Project Name: **Haverhill Consentino Middle School**

Subject: **Peer Review Changes**

PROPOSED CHANGE ORDER**No. CMS-019****TITLE: PR-04 Peer Review Changes****DATE: 08/14/2024****PROJECT: Dr. Albert B. Consentino Middle
School****JOB: CSM-2024****TO: City of Haverhill
685 Washington Street
Haverhill, MA****CONTRACT NO:****DESCRIPTION OF CHANGE**

PROPOSAL REQUEST

C2.01

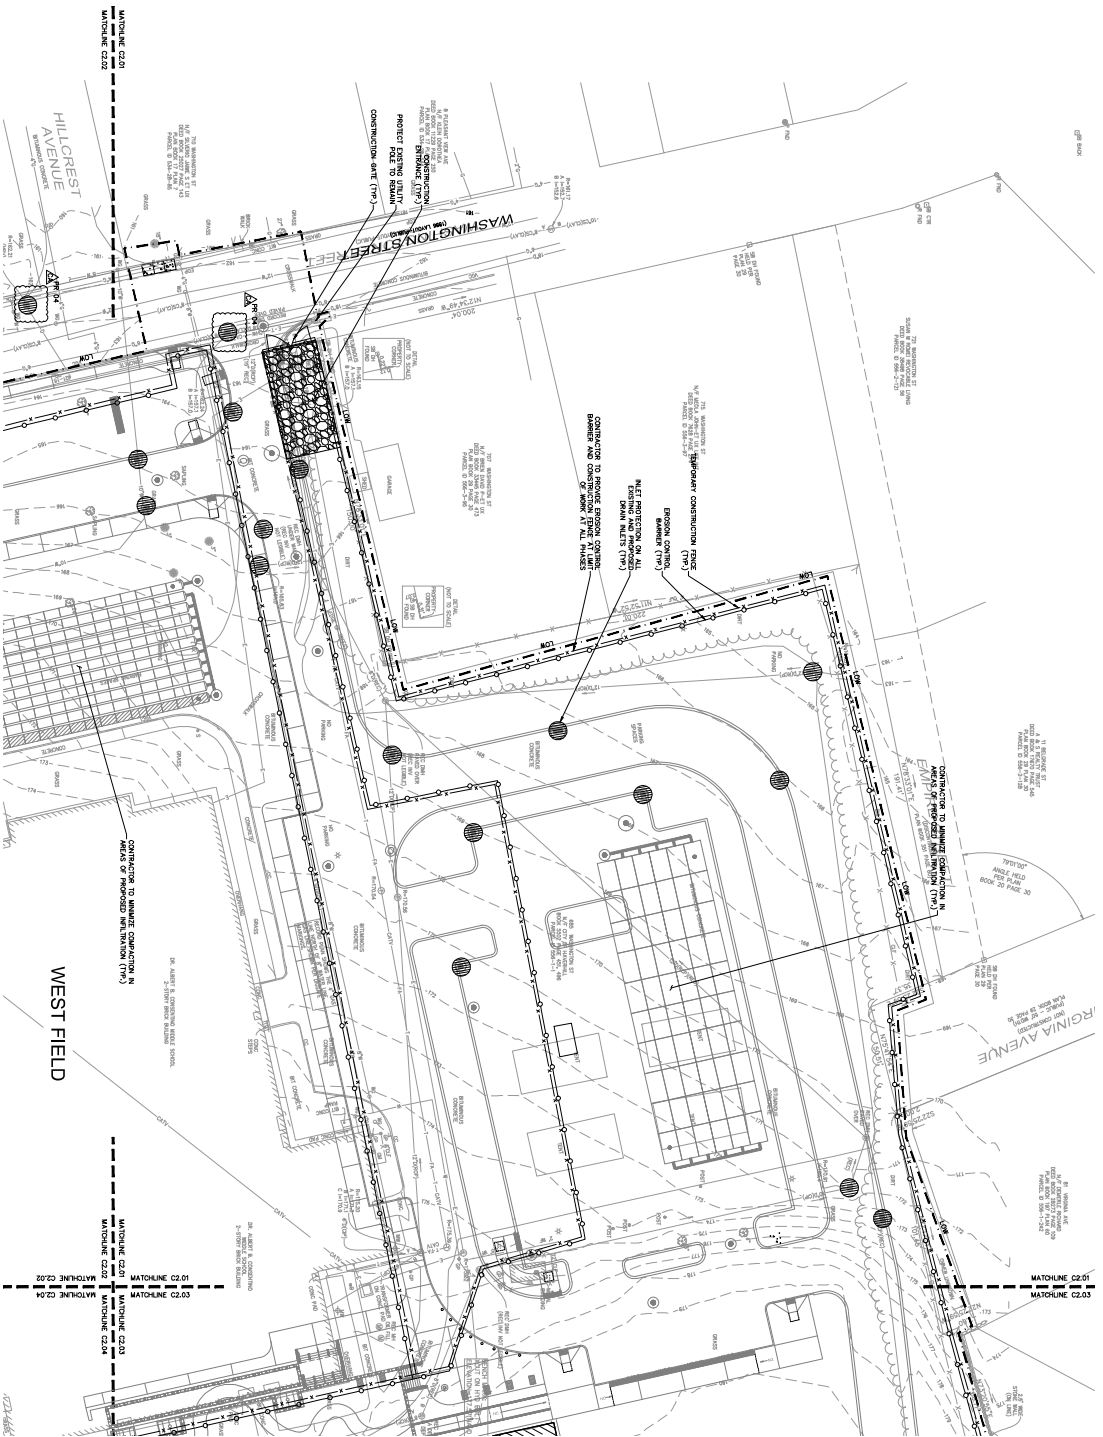
At Sheets **C2.01, C2.03, C2.04**

- REVISED erosion controls for clarity

CG.01

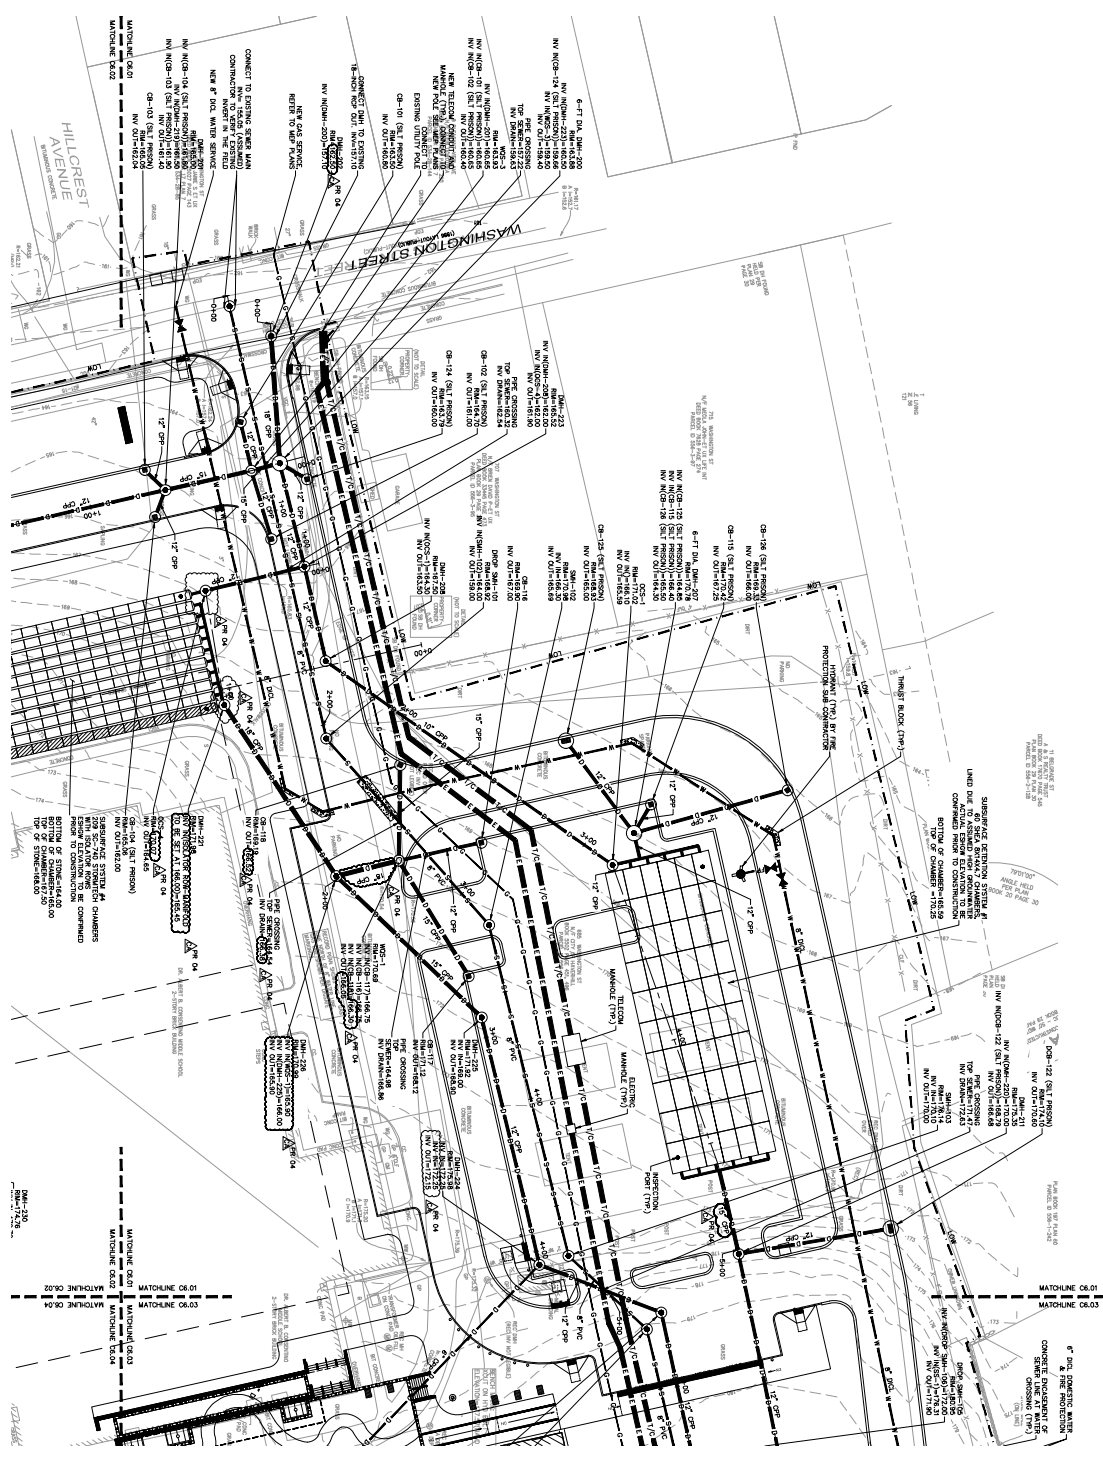
At Sheet **C6.01**

- UPDATED Rim on DMH-221 and OCS-4 to match landscape grading.
- UPDATED Rim on DMH-202 per RFI 38
- UPDATED Inverts from CB-118 to DMH-221 and pipe crossing label per RFI 38
- UPDATED pipe size from WQS-1 to DMH-226 to 18-inches
- UPDATED invert in to DMH-226 per RFI 38
- UPDATED pipe size from DMH-211 to 15"
- UPDATED inverts on DMH-224
- Provided additional info for system manifold

C6.03

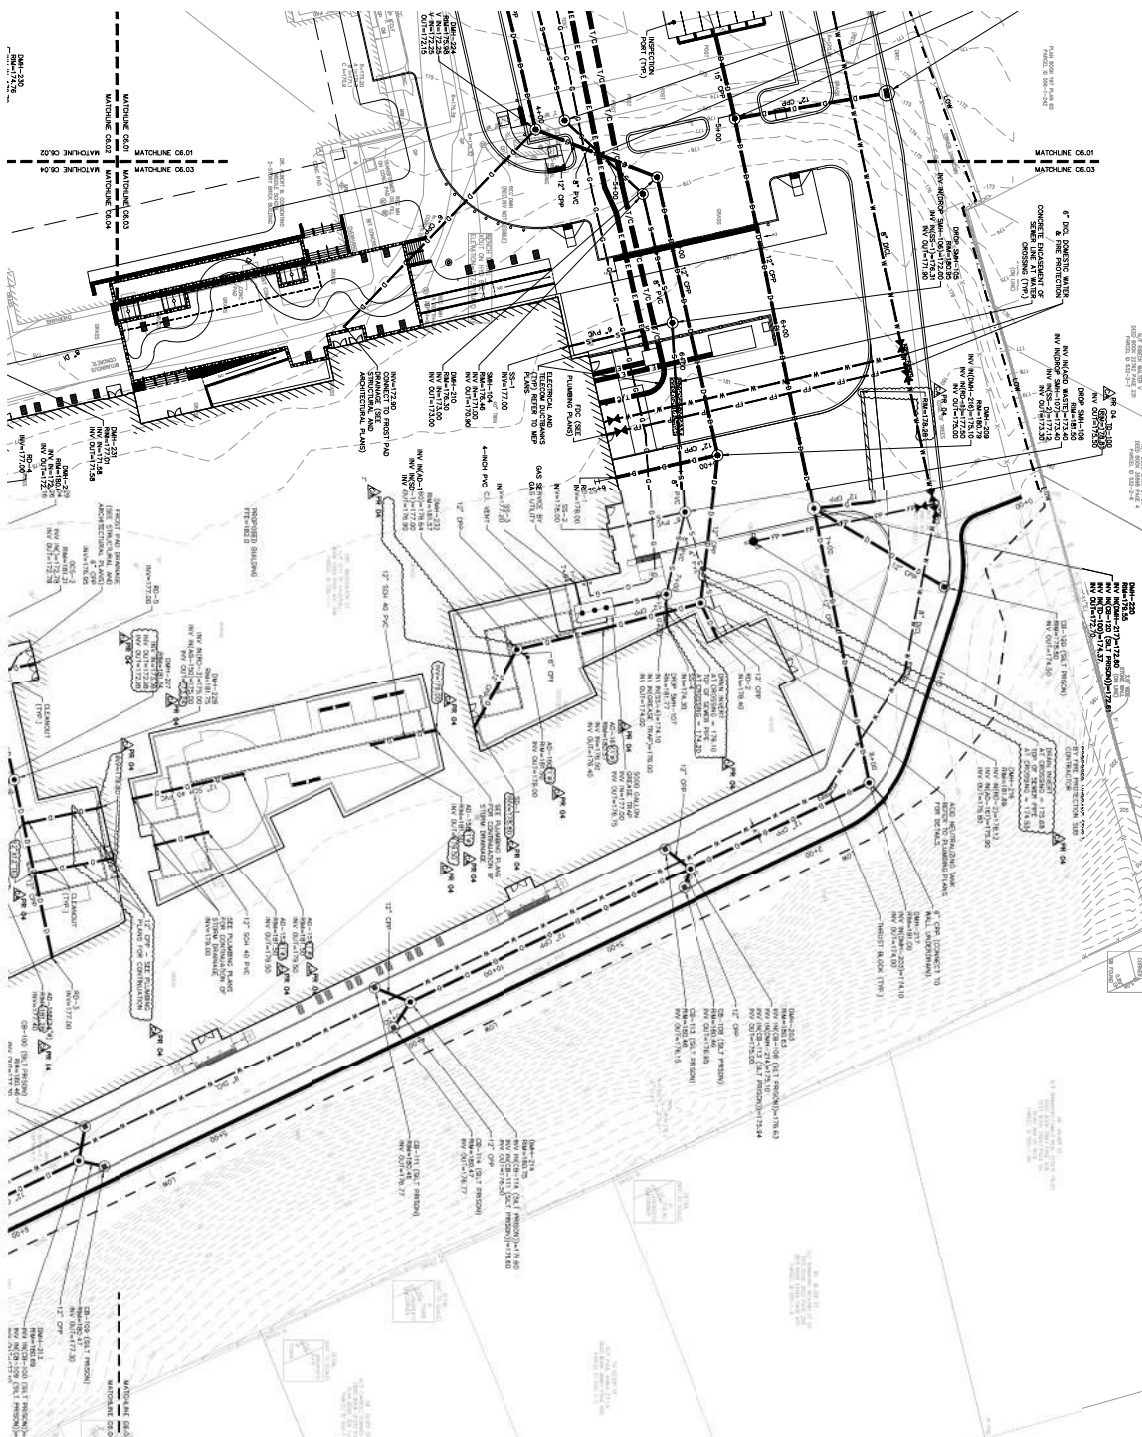
At Sheet **C6.03**

- Clarified trench drain rim elevations to match grading and intent
- Provided pipe crossing callouts for clarity
- Added area drain sizes for clarity
- REMOVED erroneous roof drain from plaza area
- UPDATED inverts at building connectors in plaza to coordinate with plumbing
